Re: **Mainstreet Parks and Buffer site plan submittal**
HSQ Project Number: **18003-32**

Please find attached the revised Park site plan per the City staff comments of April 3, 2024 and our response to comments below:

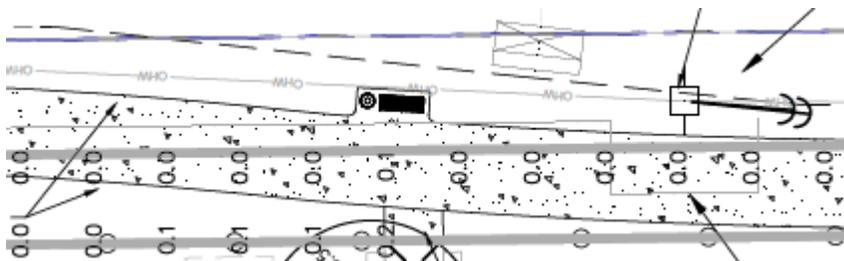
14. The lighting seems to be inconsistent throughout different sections of the greenway. There are multiple walking paths with adequate lighting, but then they lead to a seating area with minimal lighting. Examples below.

RESPONSE: Park closes at dusk. Lighting is provided for security purposes, in compliance with the code lighting standards. Not intended to be used at night.
